Additional notes provided in response to Draft IAR.

Review: Section 4_Landscape and Urban Form Macquarie Point Multi Purpose Stadium

Prepared for the Hobart City Council

In mid October 2024 Leigh Woolley Architect was engaged by the Hobart City Council to undertake a discrete review of reports that have been submitted in response to **Section 4: Landscape and Urban Form** for a proposed Multi Purpose Stadium at Macquarie Point, Hobart.

Fig. 22.9 (detail) HIPS 2015 ‘The Urban Amphitheatre’

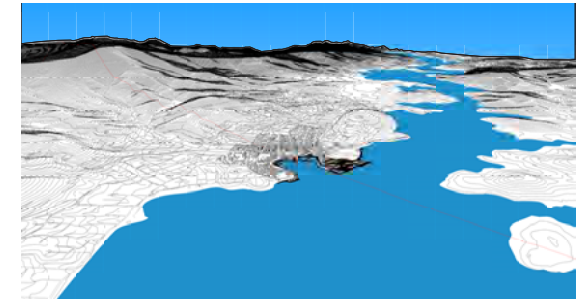
Diagrams are therefore included from the current planning scheme (HIPS 2015 NB. fig. 22.9) that reinforce the location of Urban Amphitheatre, in ‘plan’ and via axonometric ‘view’. (right opposite) These, and the context to which they apply, are however not acknowledged in either the Urban Design Framework (UDF) nor the Visual Impact Assessment (VIA). It would seem that the intent of Clause 4.1.3 (*esp. dot points 5, 6, 7, 8 and 9*) are therefore inadequately addressed.

Fig. 22.8 HIPS Diagrammatic section: The Amphitheatre to the Cove within the Urban Amphitheatre

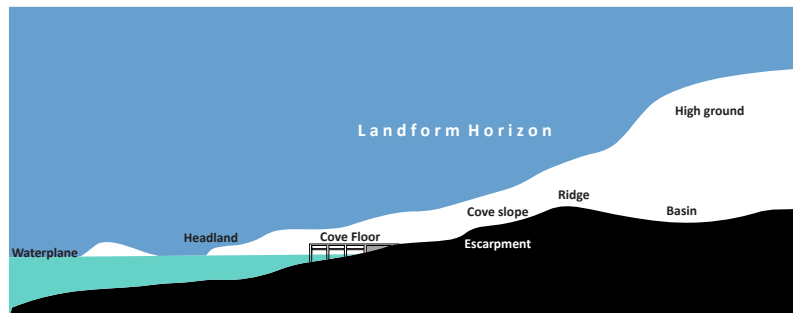
A ‘diagrammatic section’ is included in the current planning scheme (Fig. 22.8) to identify the spatial terminologies incorporated within the ‘Urban Amphitheatre’ and the ‘Amphitheatre to the Cove’. (The diagram is deliberately ‘scale-less’ and was only intended to be used in concert with the other figures, 22.7, 22.9) However it has been inappropriately copied as a literal ‘section’, (UDF p.100) to justify the scale of the proposed stadium.

Figure 133: Existing section demonstrating proposed relationship to the urban amphitheatre

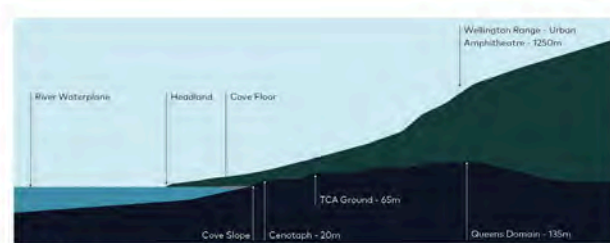
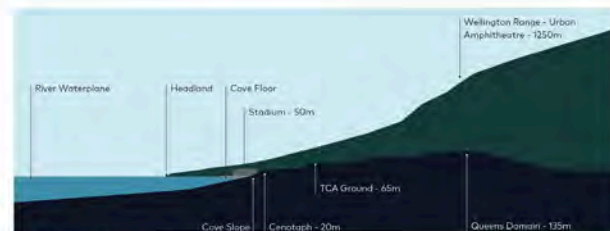
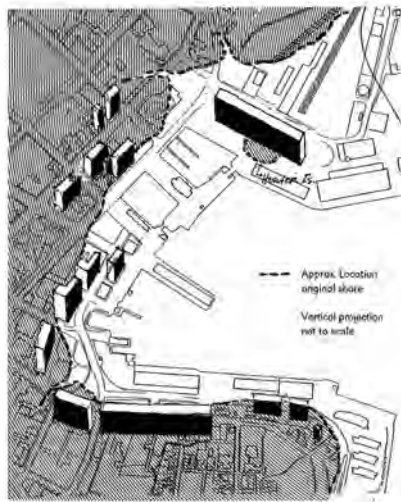
'Scale -less' diagrams copied from the Planning Scheme to inappropriately 'justify' the scale / bulk of the proposed Stadium. (UDF p.100)

View line 3 (VIA) Existing and proposed impact on views across the cove and down river.

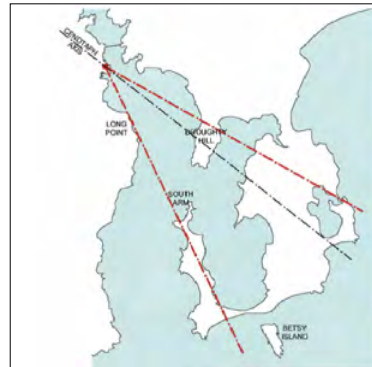
Notwithstanding architectural efforts to generate a contextual form in response to the brief, the presence of the Stadium above the Cenotaph headland is both individually prominent, and of a scale that obscures views across the Cove and down the river, especially to the 'mouth of the Derwent'.

Fig. 49 View to Hunter Street and the Cenotaph from Stowell Avenue.

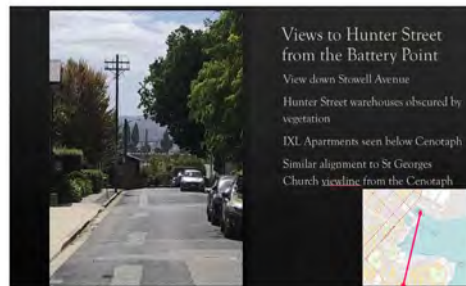
Opposite: By contrast, the view alignment deep along Stowell Avenue (p.46 SDP) is not at the Battery Point escarpment edge, it avoids alignment to the Cove Floor of Macquarie Point, and the vegetation in the street obscures the depth of view.

of the view, thus denying depth of view, (eg. Fig.49) or where alignments don't oversail the subject site at all ! (eg. Fig.48, 49). Rather than address the issue at hand, which is to develop a framework for the project site, these views instead seek to 'edit out' the site itself.

Fig.32.4 (SCPS)

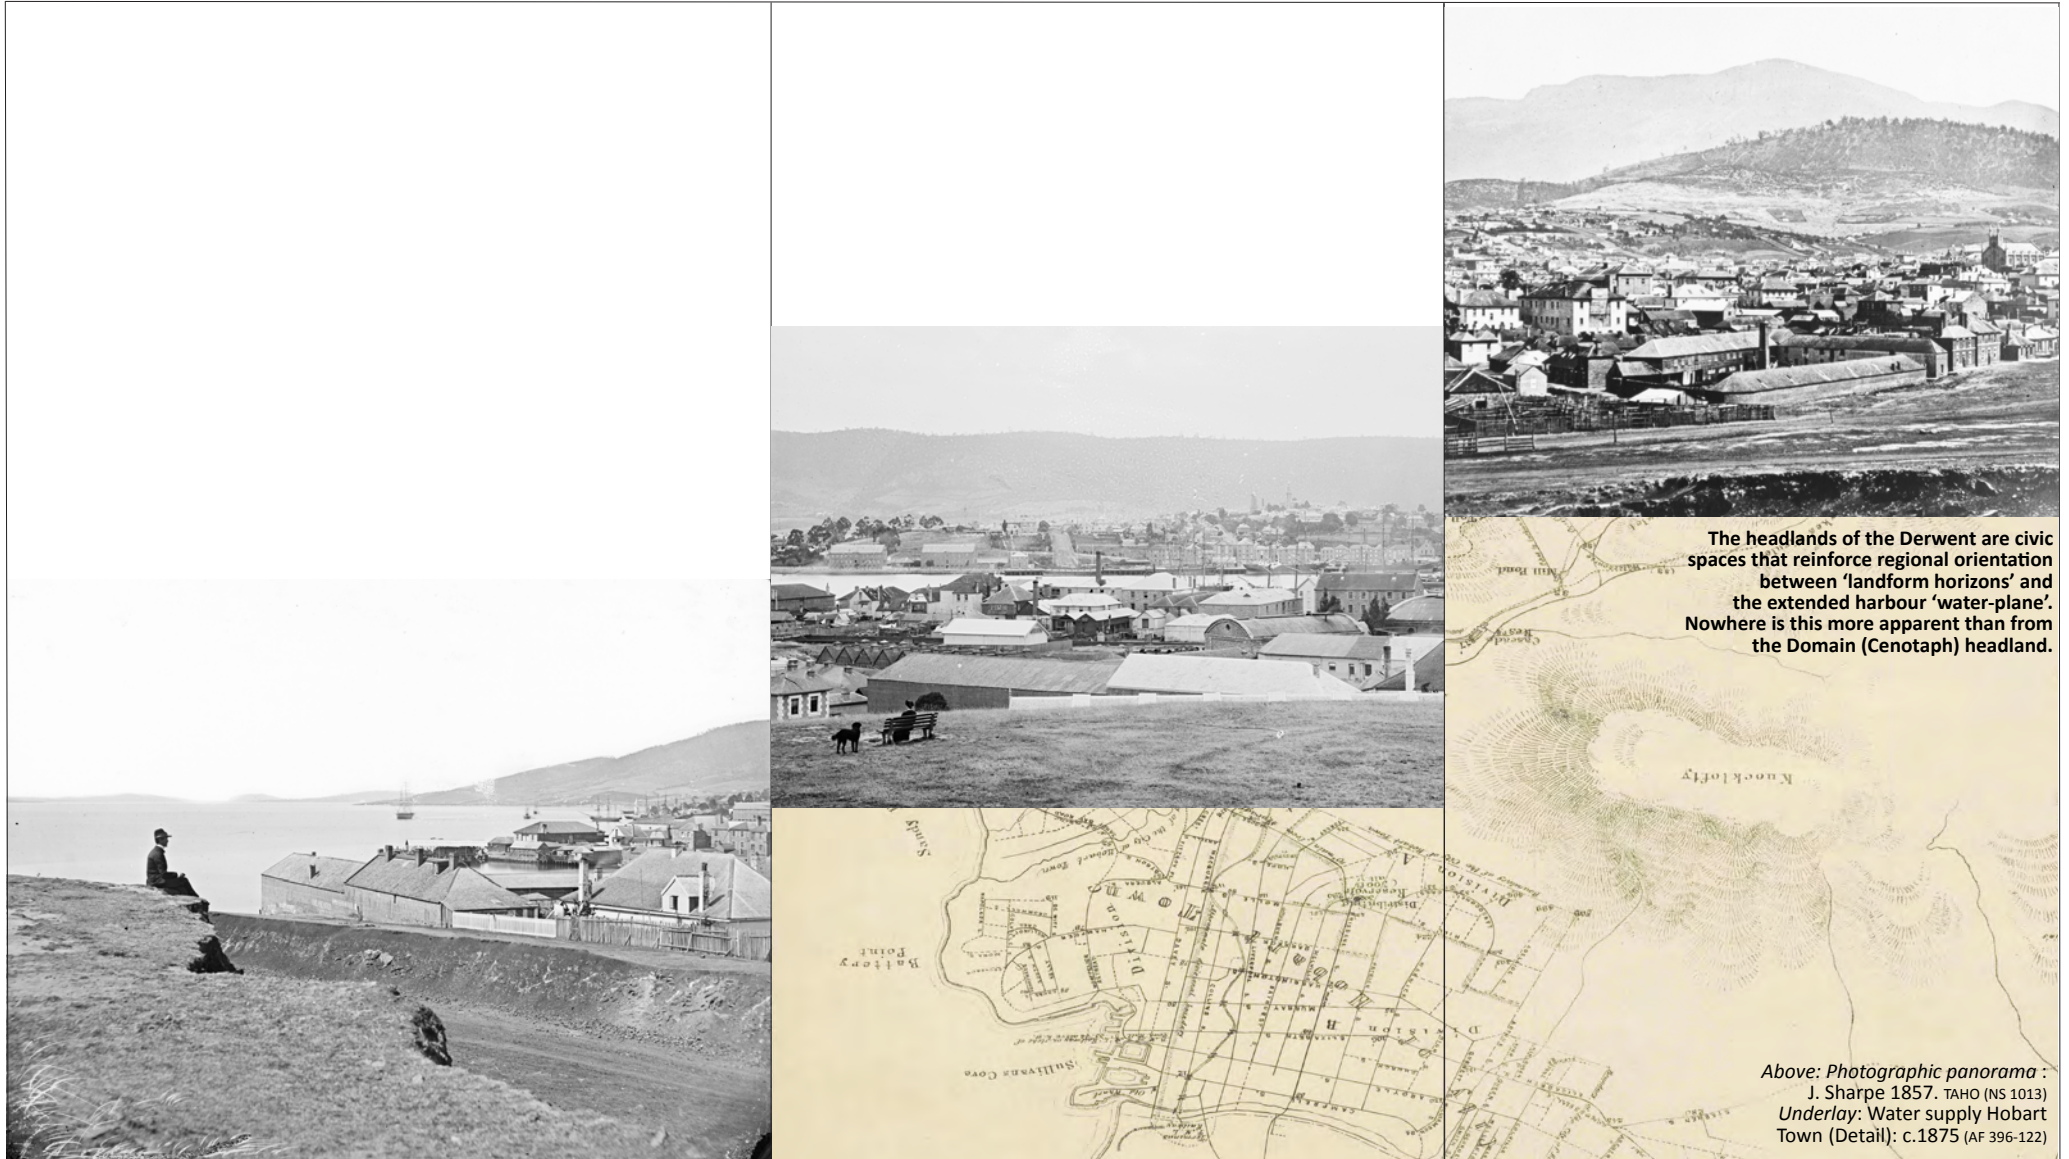
When referring to building envelope heights (Appendix GG p.59) contained within the revised MP masterplan 2017 (fig. 32.4 SCPS), the SDP (2024) does not seem to recognise that these were based (in large part) on the previously established view lines.

Accordingly, the deemed to comply heights (which varied across the Mac Point site) were established primarily in response to views out from the Cenotaph podium. The highest of these taking account of views down river and across the cove, and the lowest seeking to ensure the landform character of the Cenotaph headland was itself not unduly diminished, when viewing back across the cove.

The comment that the application of height limits is too blunt an instrument to shape and control development across a very large site, (p.62) is to disregard the anticipated layering of development back from the waterfront. At the same time it devalues or misunderstands the role of the previous development envelopes established in response to the location.

While the scale of the spaces in the Mona Re:set were less intimate, the parcels generated were in response to the location, with those closer to the toe of the headland being of less height than those located more centrally. (Refer Fig. 32.4 SCPS : Permitted heights - below)
